ADDENDUM TO BID

PROJECT: RIVERCREST CDD
MULTI PURPOSE FIELD
MAINTENANCE BUILDING & DOG PARK
POOL & CABANNA

ADDENDUM DATE: MAY 15, 2014

ADDENDUM NUMBER: 05

ENGINEER	ARCHITECT	DESIGNER
	JAH	JAH
DRAWN BY	REVIEWED BY	SCALE
JRV	JAH	As indicated
JAH #	DRAWING NUMBER	
CARD FILE #		
REV# FILE(S)		
		A5.01

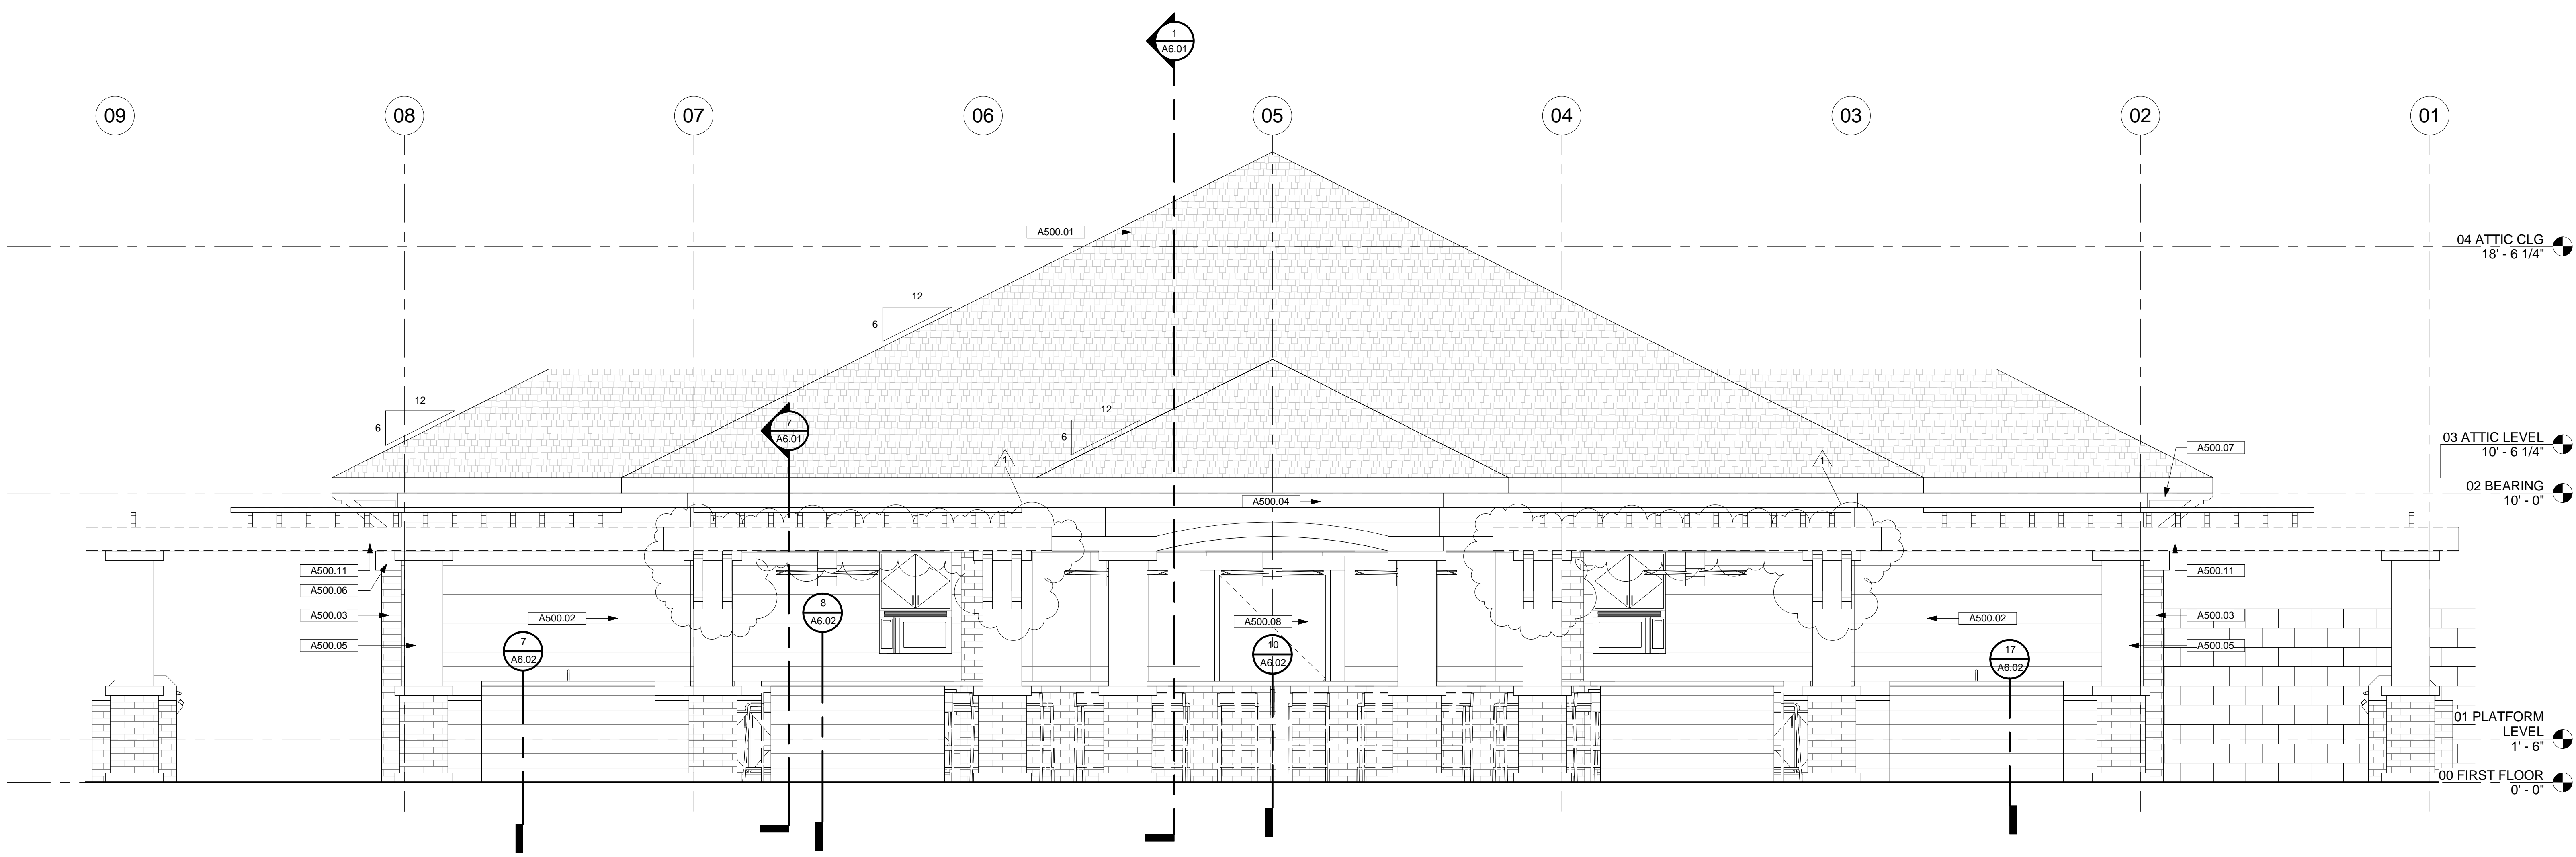
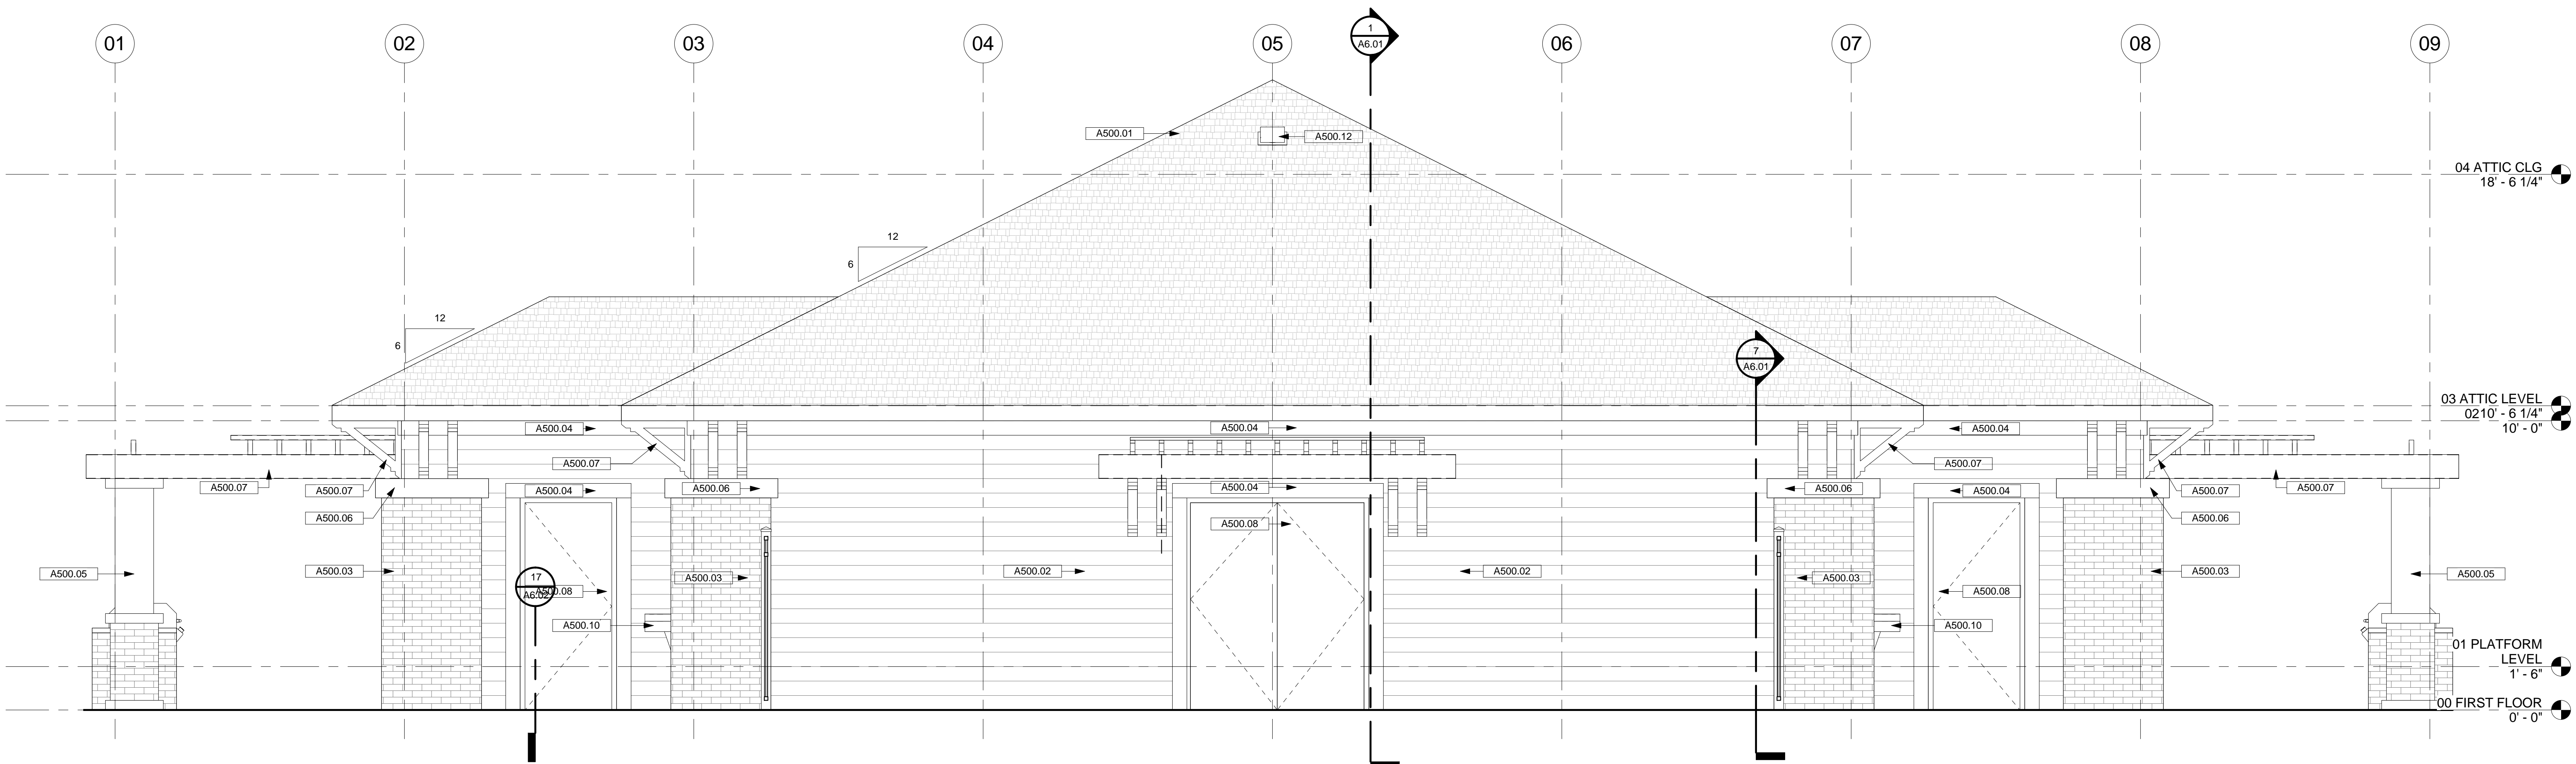
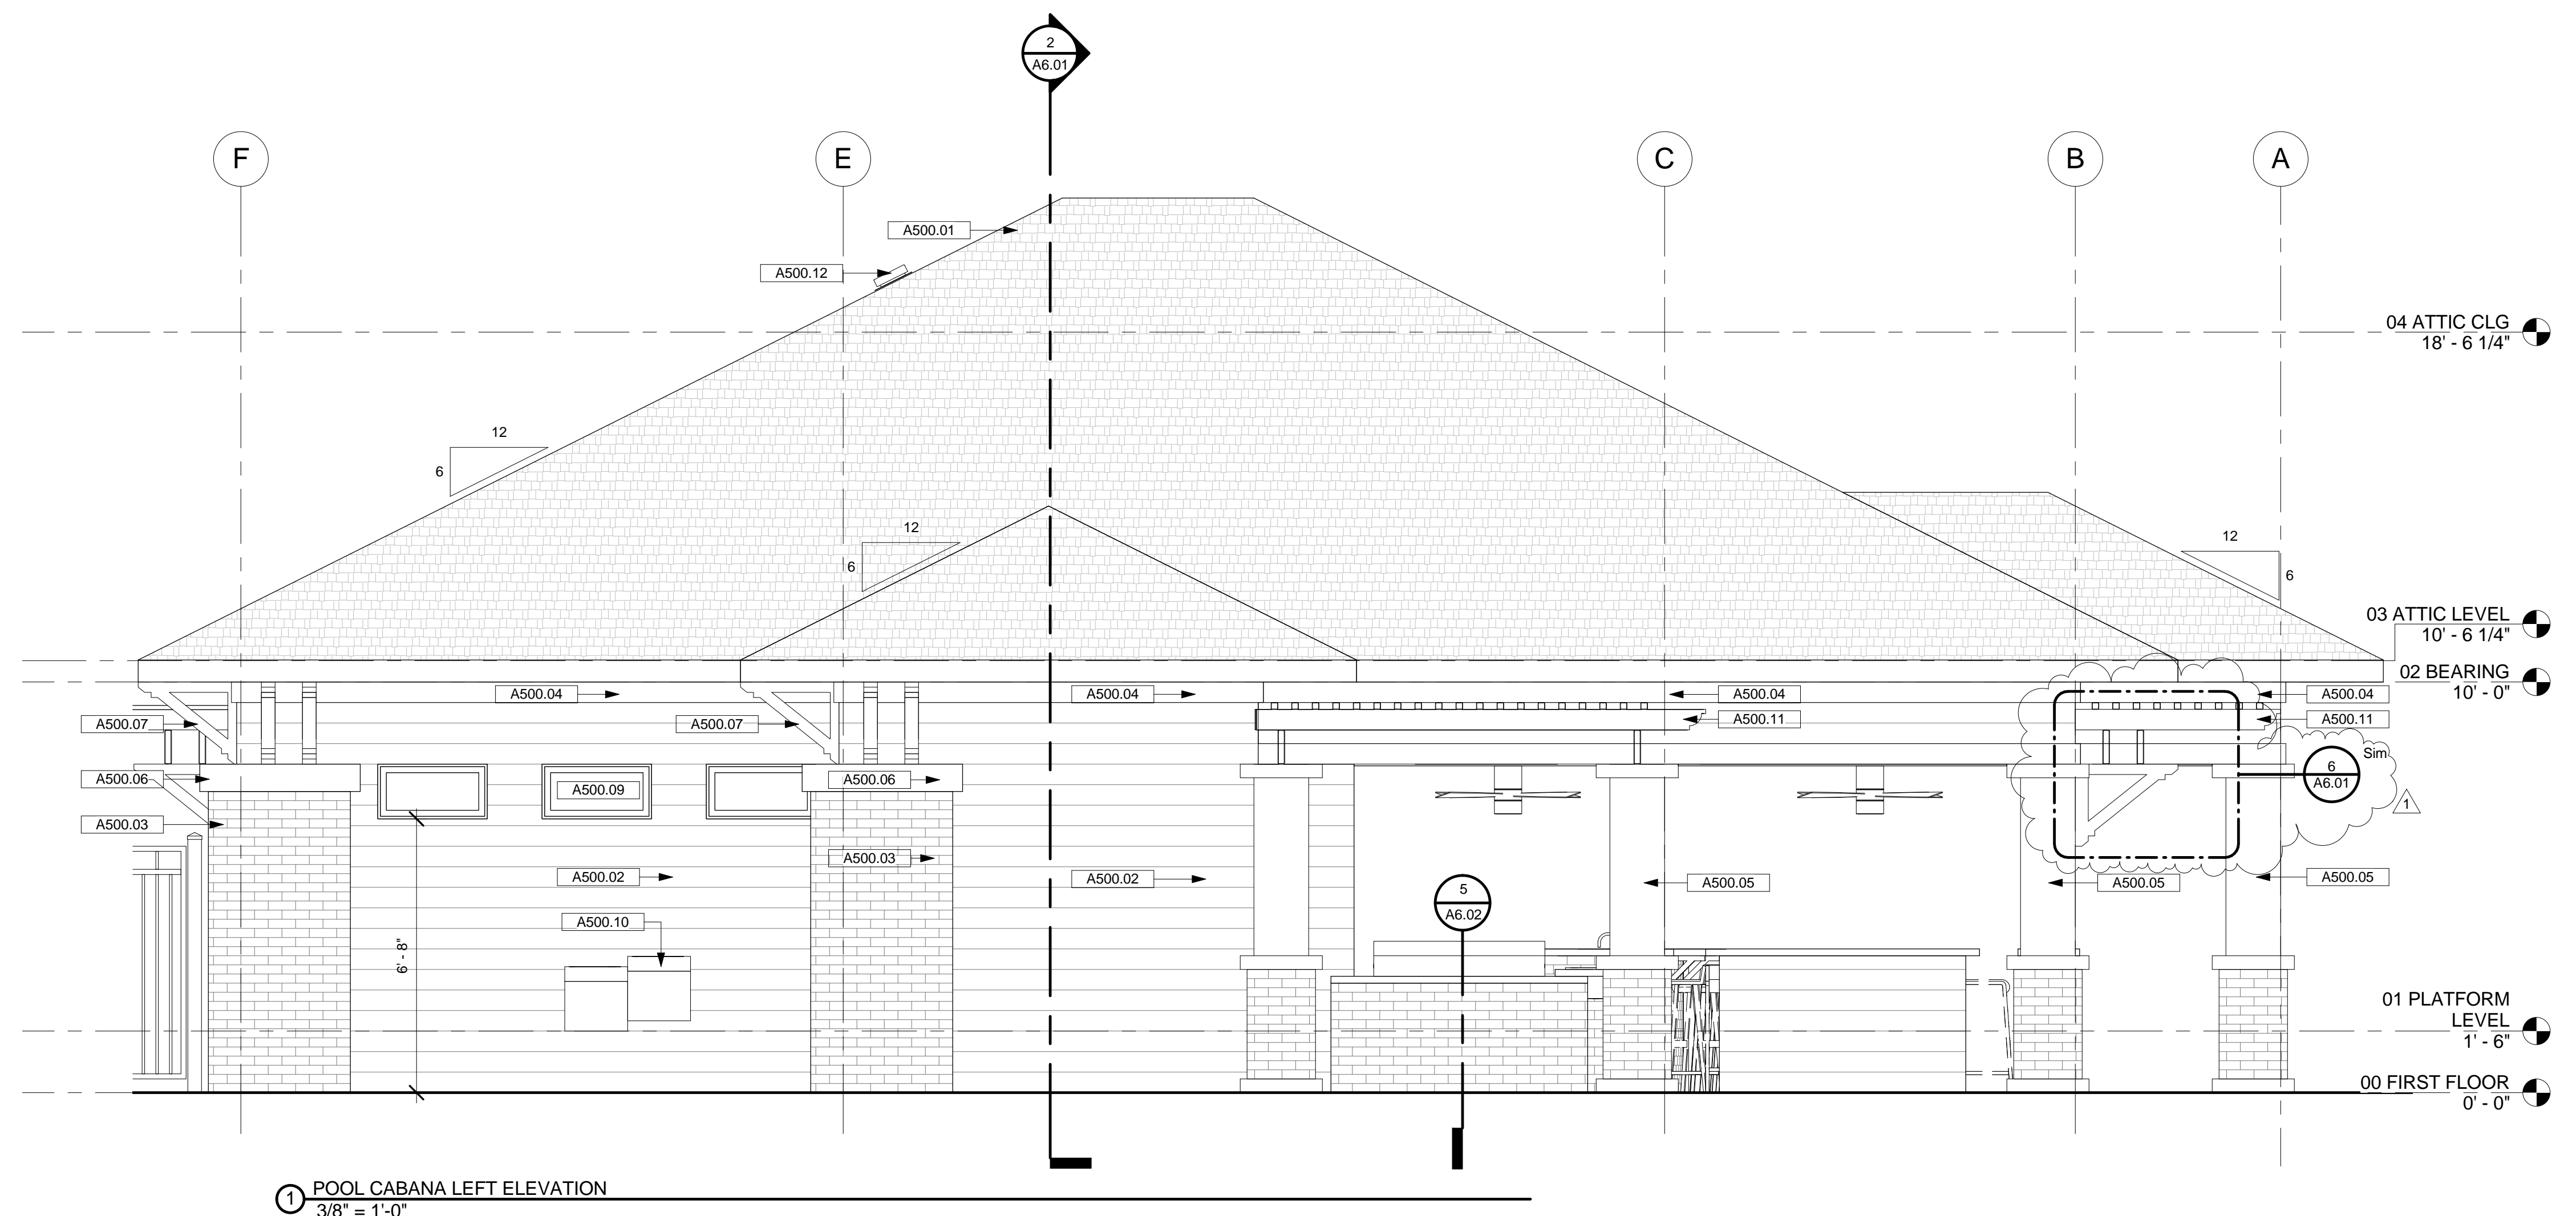
1. Question: How is the front pergola on cabana supported?
a. Answer: the support is the same as the pergola at the rear maintenance doors, see revised A5.01 & 5.02
2. Question: A7.01 is not legible can you reissue
a. Answer: yes, See A7.01 reissued for clarity. No revisions made
3. Question: how do the shade devices work on the large arched pergola with non-parallel rafters?
a. Answer: Backyard America has confirmed that the rails for the shade device will run parallel by use of a continuous PVC wedge shaped horizontal support.
4. Question: Stabil Paver pattern "B" 8"x8" cannot be manufactured on a 2-3/8" thick paver. What can be done?
a. Answer: Paver Pattern "B" 8"x8" can be substituted by using a (2) 4"x8" on a "basket weave" pattern. Color and thickness DO NOT change.
